Our Ref: 949-02-CIV-Planning Condition 15 response

**Medieval Quarter Glade of Light
23 March 2021**

Response to planning condition 15 - Drainage and flood risk

See below response to planning condition 15 relating to surface water drainage and flood risk for the Medieval Quarter Glade of Light development.

Project	Medieval Quarter Manchester
Title	Existing Drainage Phase 1A
Scale @ A1	1:250
Date Created	18/03/21
Drawn	CK
Checked	CK

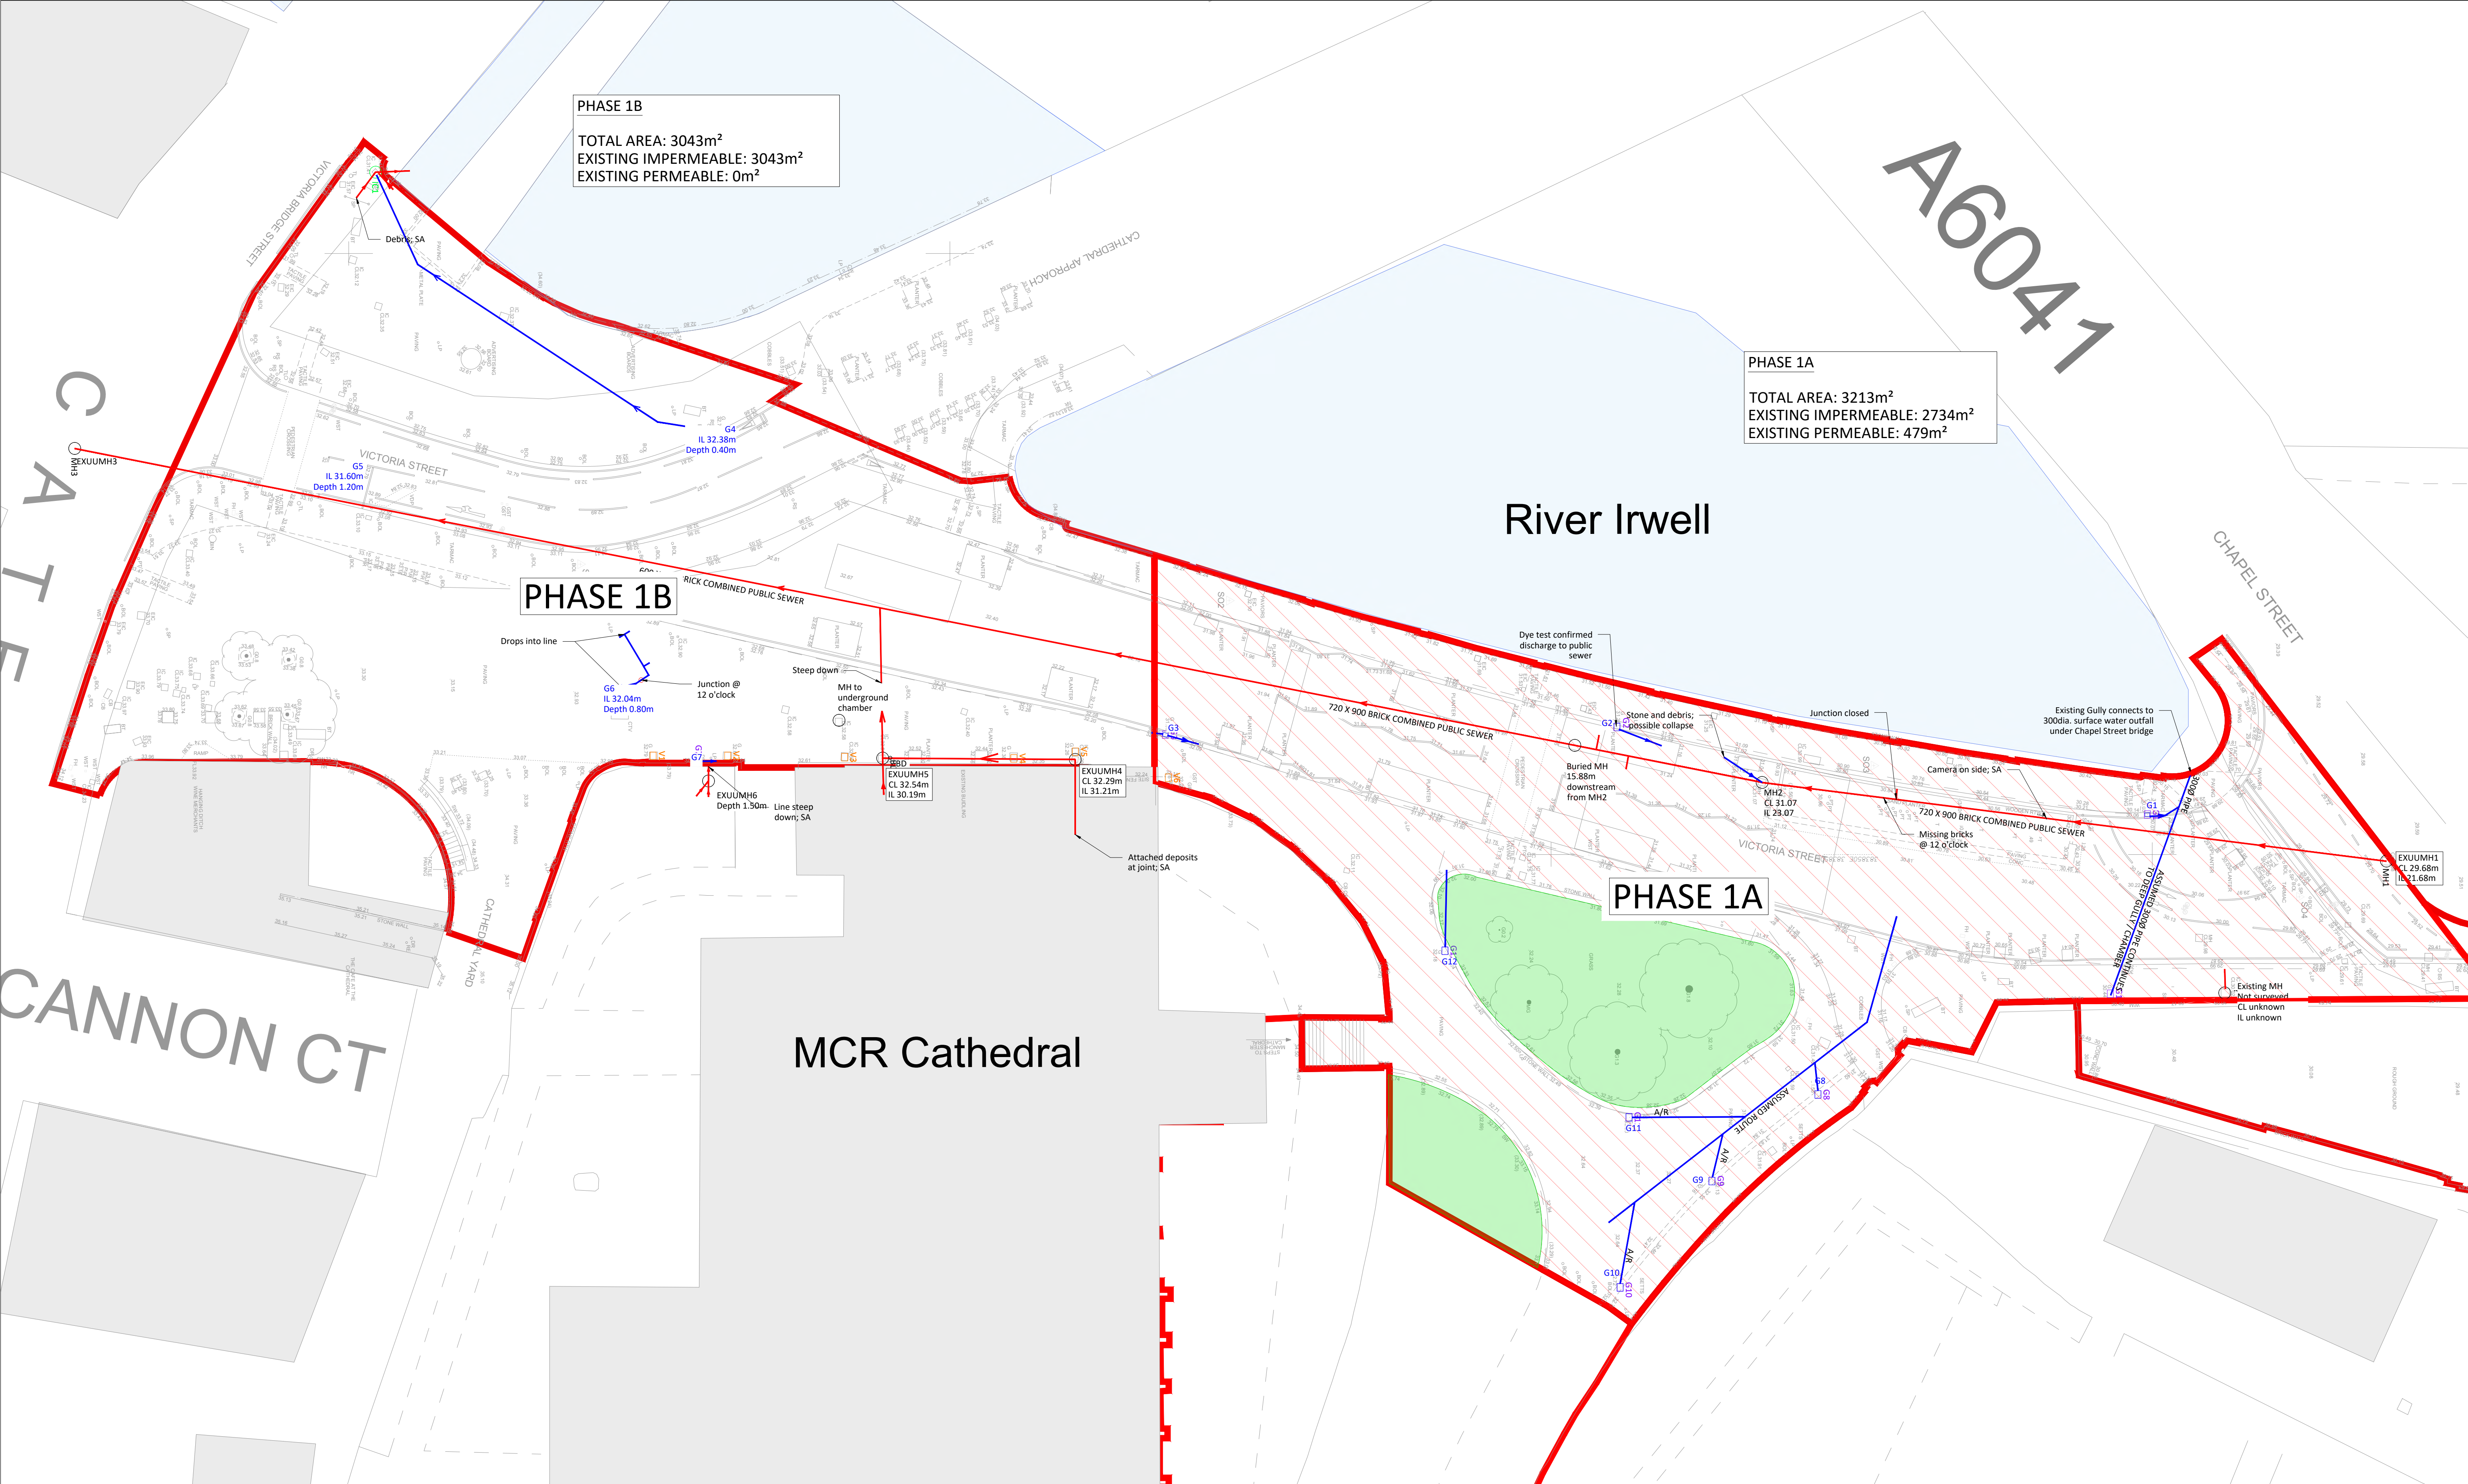
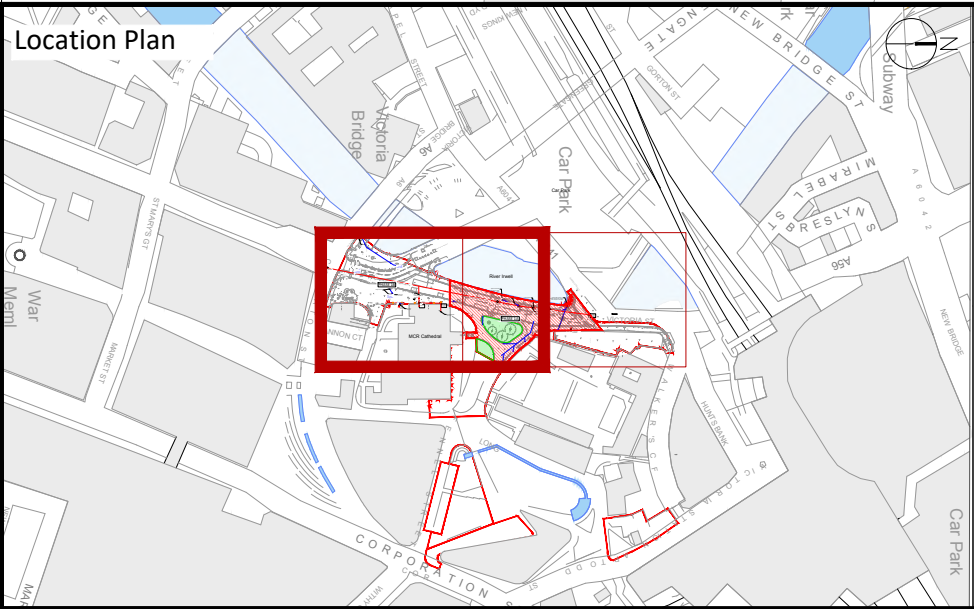
To begin our discussion on proposed rates, could you please discuss how existing rates have been calculated, what existing network the site was determined to drain to, & confirm that this existing network has been modelled in your attached calcs. At the point of formal FRA submission for this App, the existing drainage regime was unclear. We subsequently received the below text from the applicant via email 12 Nov 2020.

"The original CCTV survey was inconclusive and could not determine connections to either the public sewer or directly into the River Irwell. Therefore a further investigation was undertaken on 12th October which proved a highway gully connection to an existing 300 diameter piped outfall to the Irwell. This outfall is at a convenient location for the Phase 1A (and 1C) development as it is at a low point of the site. The only challenge with this outfall is that the invert level is approximately 1m below the nearest ground level (estimated based on observation). If the drainage strategy were of a traditional nature, i.e.: gullies, channels and pipes then connection to this would be a lot simpler to achieve. The difficulty arises with the depth of raingarden sub-bases which are used for storage. A strategy has been developed which introduces a shallower detail to raingarden nearest the outfall in order to utilise the existing Irwell outfall."

As per our comments, as the EA is risk management authority for main rivers, any works within or adjacent to the river that would affect it would require consent from Environment Agency. You have stated that you have approached the EA; and they have no objection or stipulations, and have directed you back to the LLFA. An email of acceptance of proposed flows and/or new connection will suffice to discharge this part of our comments.

In addition, the existing highway is drained by traditional highway gullies. The attached plan shows the existing drainage including the existing 300dia. outfall into the Irwell. Currently there are several gullies which connect to the public sewer and the gullies at the lower end of the catchment discharge to the existing outfall. The proposal involves disconnecting the gullies from the public sewer and instead utilising the existing 300dia. outfall as the means of surface water disposal for the full catchment. I also include a link to the CCTV drainage survey of the existing outfall here showing the survey of the nearest gully outlet opening up into the 300 outfall pipe:

By removing surface water from the combined sewer we are complying with step 2 of the hierarchy of surface water disposal. Due to the sensitive nature of the site with existing utilities and underground catacombs associated with the Cathedral, surface water disposal by infiltration is not feasible.

The existing area within the Phase 1A site is 3213m²
The existing area within the Phase 1B site is 3043m²

Due to the gradient of Victoria Street, Phase 1B will eventually drain into the new surface water system provided by Phase 1A, therefore the total brownfield run-off from Phase 1A and 1B has been calculated. The existing 1:1 year run-off is 86.5 l/s which when offering a 50% betterment in accordance with Manchester SFRA, gives a discharge rate of 43.25l/s.
